Project: OLDHAM ROAD, NEWTON HEATH

Drg Title: DRAINAGE LAYOUT PHASE 1 - SITE 2

Project No:	Originator:	Volume:	Level:	Type:	Role:	Category / Number:	Rev:
074031	CUR	00	XX	DR	C	92501	C03

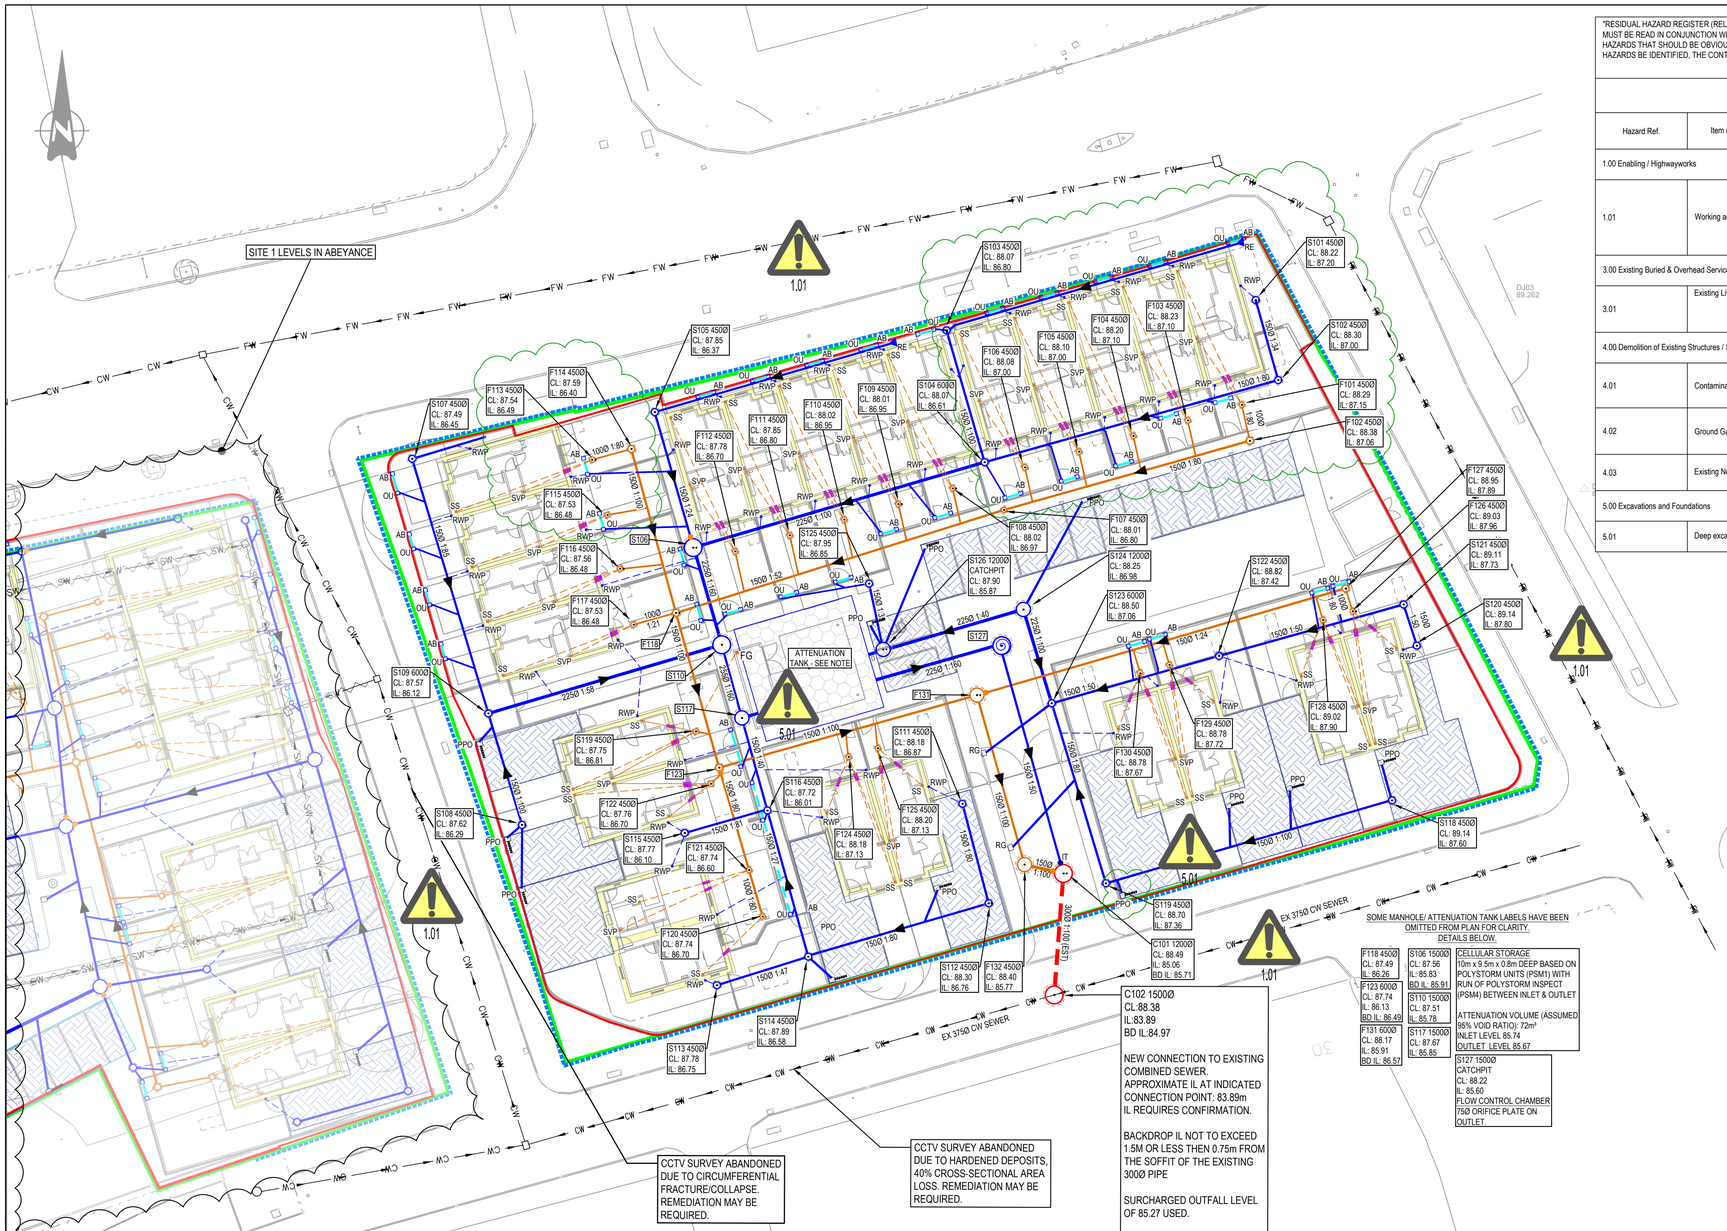
- COVER LEVELS AMENDED GLOBALLY IN LINE WITH REVISED CONTOUR & SITE PLANS, AND REVIEW WITH MANHOLE SCHEDULE.
- DRAINAGE CHANNEL, RWP, FOUL CONNECTION AND PERMEABLE PAVING LOCATIONS AMENDED IN LINE WITH REVISED CONTOUR & SITE PLANS.
- INVERT LEVELS AMENDED TO REFLECT REVISED FFL LEVELS.
- FOUL CONNECTIONS PASS THROUGH STRIP FOOTINGS IN LINE WITH REVISED TOP OD FOOTING LEVELS.

REVISION CLOUDS HIGHLIGHT WHERE LOCATIONS OF ITEMS OR PIPE GRADIENTS HAVE CHANGED (FOR CLARITY). COVER AND INVERT LEVEL AMENDMENTS ARE CLOUDED ON THE MANHOLE SCHEDULES
